JUSTIFICATION

RE-USE OF ATTIC FLOORBOARDS

2. Proposed Site Plan

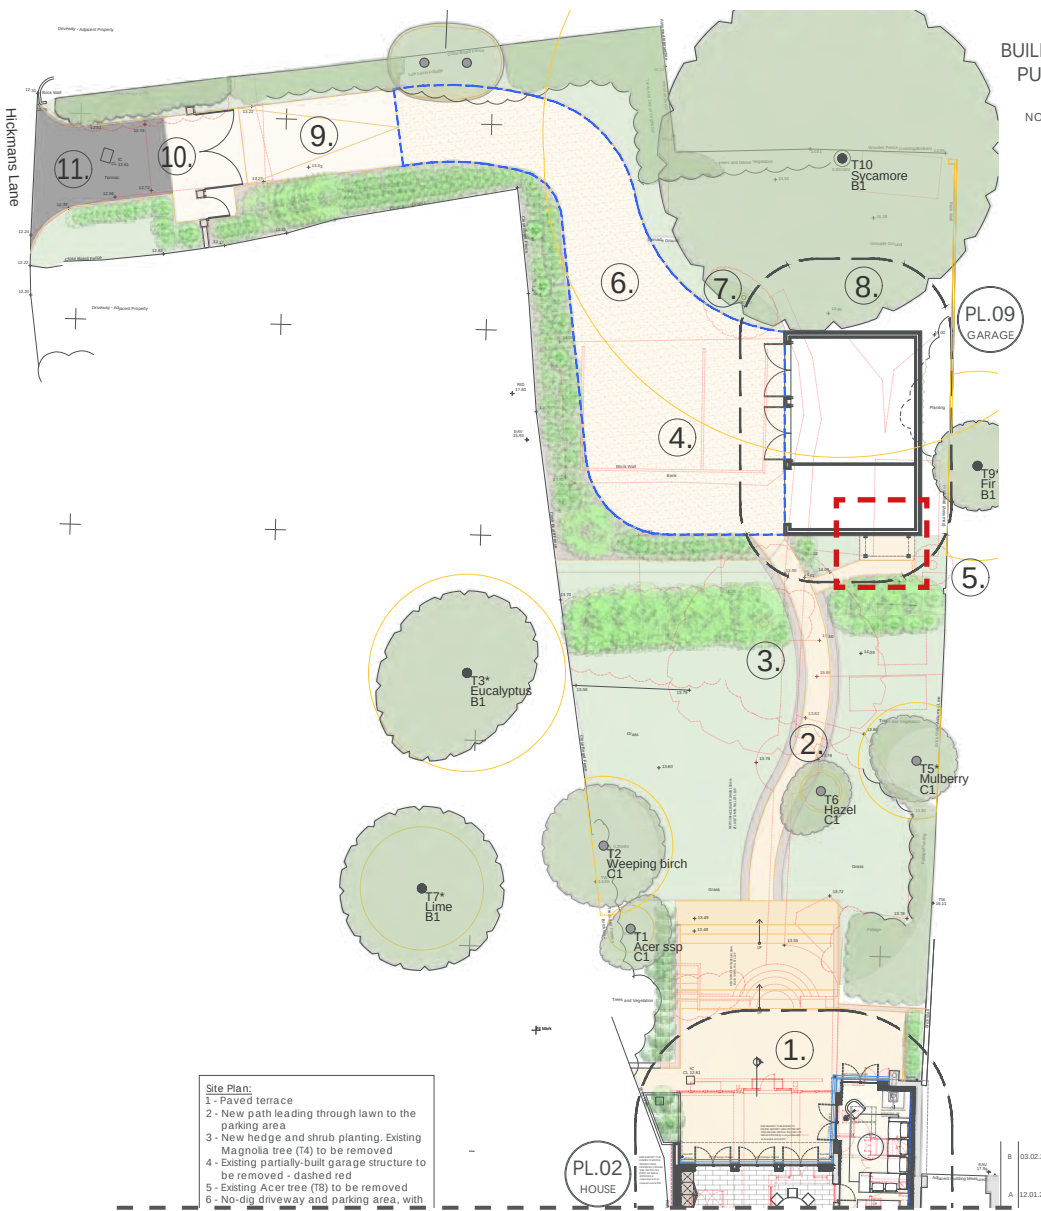
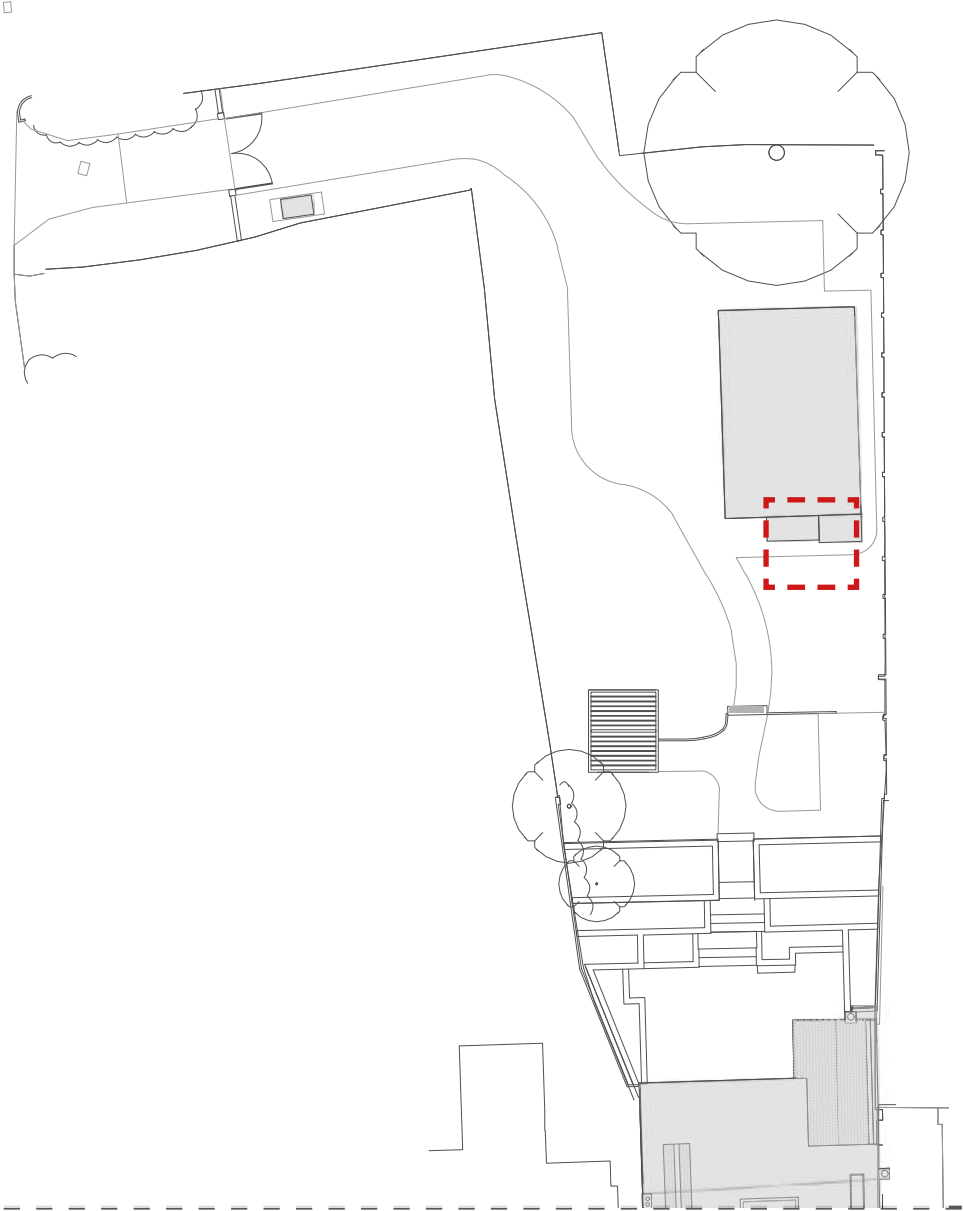
The garage has been constructed with minor variation to the approved scheme - the approved log store was constructed lower and in shifted location (centre of the elevation instead of side).
